State Planning Commission

AMENDMENT to the ASSESSMENT REPORT

IWS NORTHERN BALEFILL – LOWER LIGHT

Integrated Waste Services (IWS)

Figure 3: Modules 3-11 Cap and Processing pad (AEIS July 2022)

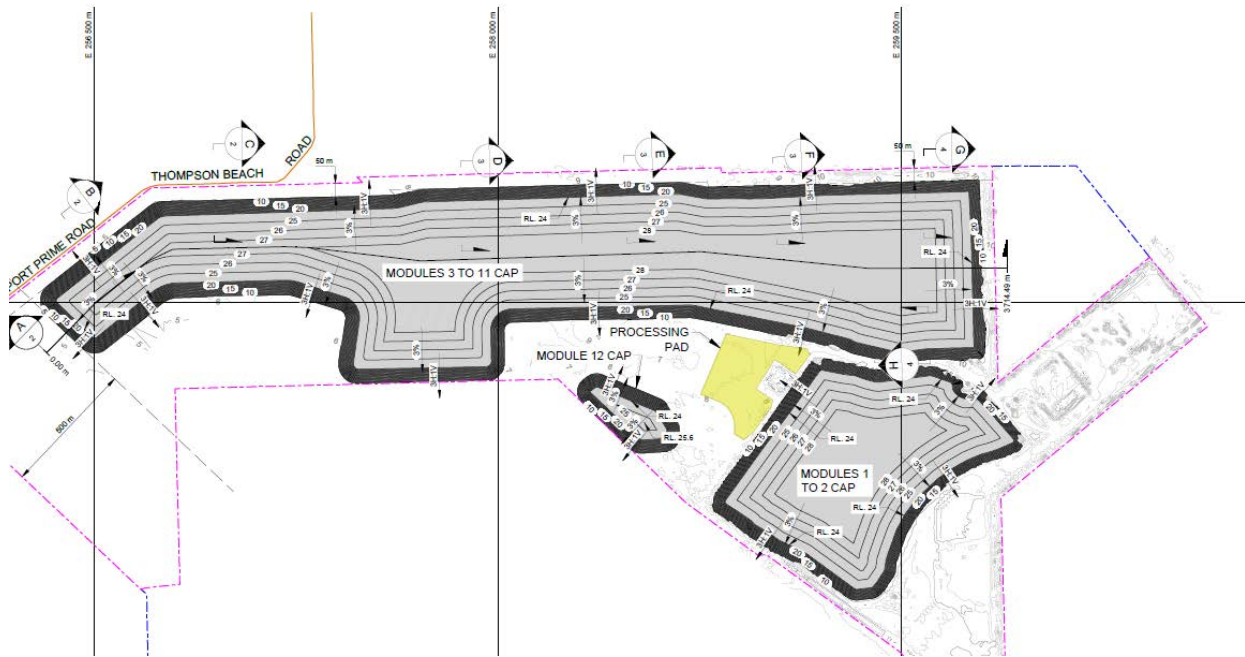
The proposed variation seeks to clarify that cell processing pads can be established on areas shown to be used as future cells. The AEIS states that utilising cell areas as processing pads, this allows for a significantly increased efficiency in the movement of material through the site.

Figure 4: Typical Perimeter Profile (AEIS July 2022)

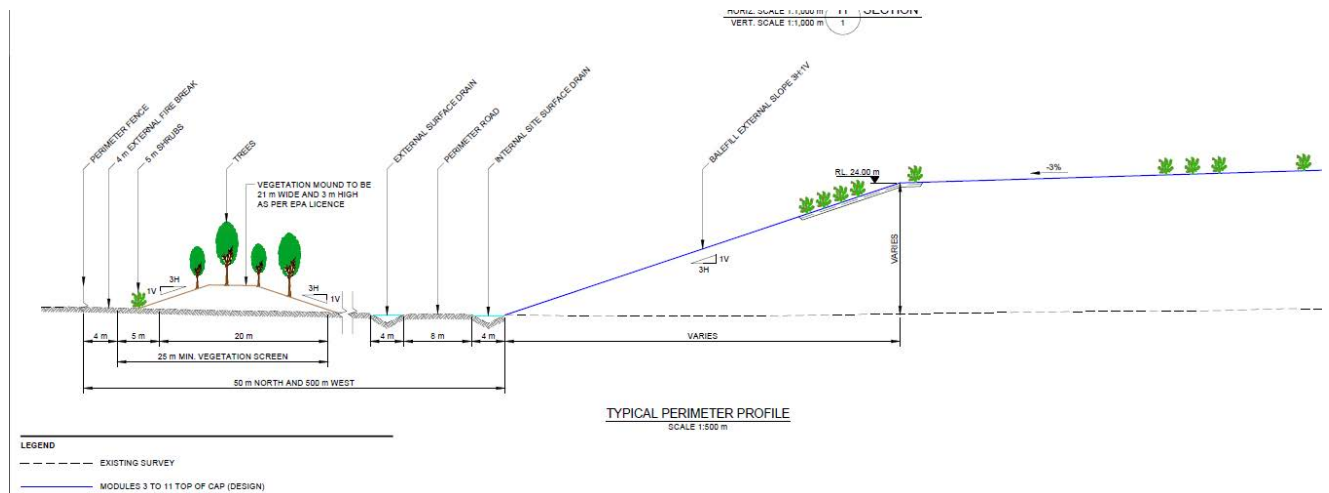
The variation seeks an increase to the permitted height of the landfill cells from a currently approved maximum of 23.00 metres AHD to a revised maximum of 28.00 metres AHD.

The increase in height will provide flexibility in cell design to suit operational and geotechnical conditions (such as such as alternate liners, reduced depth of excavation, increase distance between cell liner and ground water, alternate cap designs). The height increase is not anticipated to impact the existing groundwater, surface water, landfill gas management.

44. The final height of finished modules (which includes interim cover and capped modules, which contain multiple cells) must not exceed the three-dimensional space defined in the EIS Amendment Appendix J – Golders Cell Module Layout Plan (Titled MODULES 1 TO 2 CAP, MODULES 3 TO 11 CAP AND MODULE 12 CAP - LAYOUT PLAN and MODULES 3 TO 11 CAP SECTIONS - SHEET 1 OF 3 dated 3/2/20230), and the maximum permissible height of 28 m AHD.
